Hampstead Heath Consultative Committee

- a) Hampstead Heath Ponds Project - Assessment of the Design Flood (Pages 11 - 82)

| Subject: Hampstead Heath Ponds Project – Assessment of the Design Flood | Public |

Figure 5-2 Flood map around the ponds for the PMF event

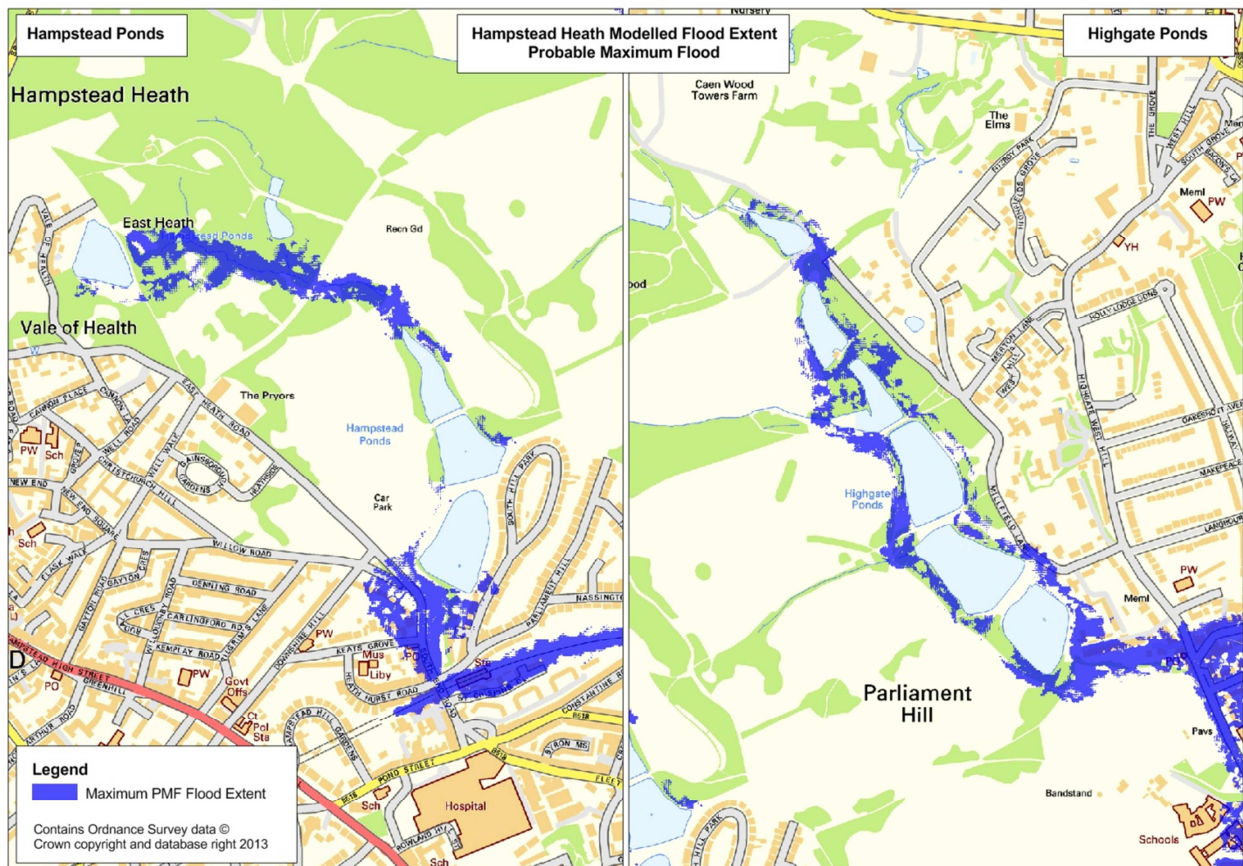
- ES asked about the maps and whether they could see a map with the residential areas marked so they can see which areas the Atkins review shows too be at risk of flooding. AH said the Environment Agency have published maps but said that they were to be used with caution as they are not precise enough to show a specific address. AH said CoL had not asked for maps but they could be provided. CL and MP said they would also like to see maps; IH hoped the CoL would be able to see that such maps are provided. PM said the Haycock maps are on the website as well as the Environment Agency maps.
